City of Albuquerque Development Review Board
Submitted on: July 28, 2020

Project No. 1005354

**Final Sign-off for EPC-approved
Amended Site Development Plan for Subdivision and Building Permit
Sawmill Village Redevelopment - Phase 2
Tract 2-D-1 of ARBOLERA DE VIDA, Unit 2B
(To subdivide into Tract 2-D-1A and 2-D-1B)**

This letter is in support of Applicant's Application for an Administrative Amendment of the existing approved Site Development Plan for Subdivision and Building Permit.

DATE: 9/29/16
 REVISIONS
 CAD DWG FILE:
 DRAWN BY: LS
 CHECKED BY: RSE
 COPYRIGHT:
 DESIGN PLUS, LLC
 SHEET TITLE
 SITE DEVELOPMENT PLAN FOR BUILDING PERMIT AND SUBDIVISION
 V.3
 SDP 1.0
 SHEET 0F 00

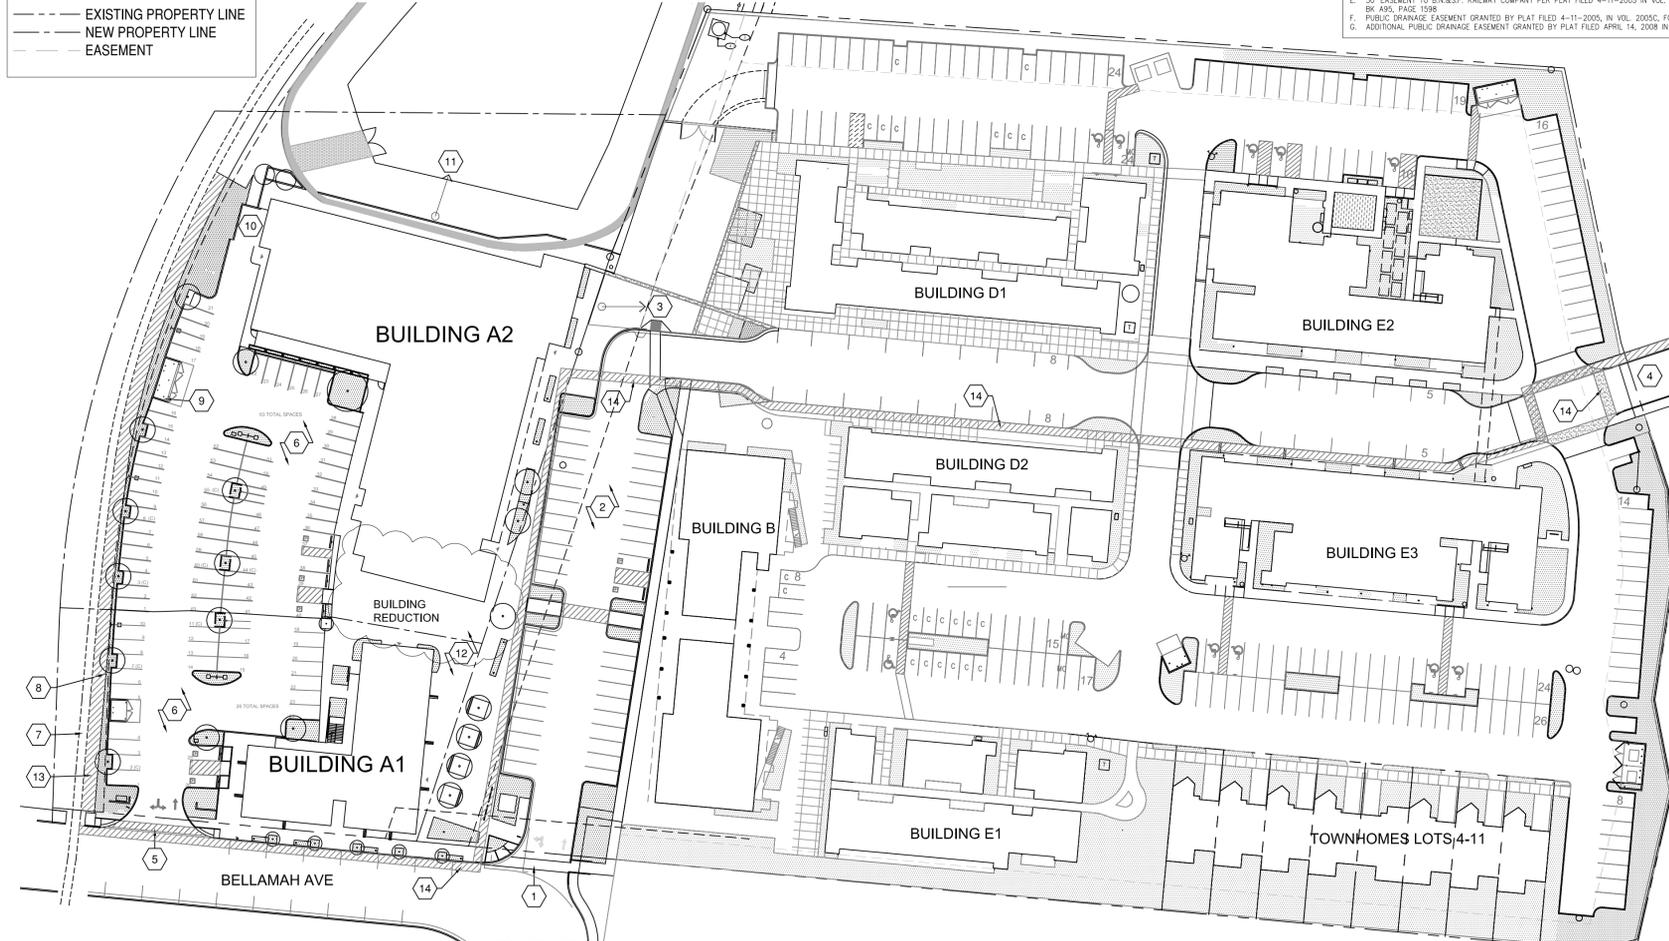
The approved SDP for subdivision and Building Permit and subsequent approval from DRB dated 07/27/2016 (see included in the Drawing Attachment) anticipated a two story 44,000 GSF Public Charter School Building ('Building A2') on track 2-D-1B on SDP. This facility was designed to accommodate total of 450 middle and high school students. However, the School has since then decided to reduce the capacity to total of 350 students, which has resulted in the reduction of overall building area to 38,300 GSF (reduction of 8.7% of total area). Most of this reduction occurs on the 2nd floor footprint. There is also a minor reduction (less than 10%) to the 1st floor footprint.

Overall, there is less than 10% reduction in Building Volume and Elevations. Other components of approved DRB documents such as finishes, windows, colors, heights, landscape, site work scope, remain the same.

Although required parking can be reduced from approved 60 spaces to 47 (10 Middle School classrooms x 2/ CR + 9 High School Classrooms x 3/CR), project will keep the same number of parking spaces and previously approved DRB documents.

We are including original approved DRB coversheet V-3 SDP-3.0 with sign off date of 1/27/2017, along with proposed documents with reduced building footprint, and elevation. The grading and drainage design remains the same since the overall site plan remains the same.
